Product Change Notice (PCN)

PCN Number: **PCN-0456180R-02**

Product(s) Affected: **PJ-041H**

PREVIOUS CUI DEVICES DETAIL / IMAGE	NEW CUI DEVICES DETAIL / IMAGE

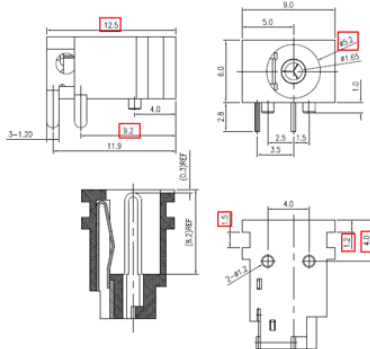
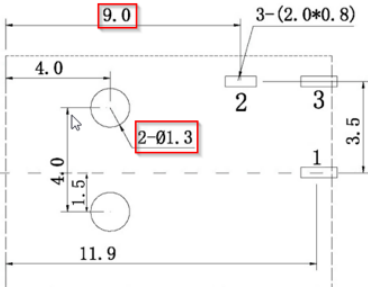
Description of Change: **New Factory Location. Product re-engineered for improved manufacturability and production yield. See image below for reference and check CUI Devices website for updated drawing. Cosmetic differences may be visible and not affect the form fit and function of the product.**

PREVIOUS CUI DEVICES DETAIL / IMAGE			NEW CUI DEVICES DETAIL / IMAGE		
DESCRIPTION	MATERIAL	PLATING/COLOR	DESCRIPTION	MATERIAL	PLATING/COLOR
center pin	brass	silver	center pin	copper alloy	silver
terminal 1	brass	silver	terminal 1	copper alloy	silver
terminal 2	C5191 phosphor bronze t=0.30	silver	terminal 2	copper alloy	silver
terminal 3	C5210 brass t=0.30	silver	terminal 3	copper alloy	silver
housing	PA66 (UL94V-0)	black	housing	PPA (UL94V-0)	black

MATING PLUG
Jack Insertion Depth 8.9 mm

MATING PLUG
Jack Insertion Depth 8.2 mm
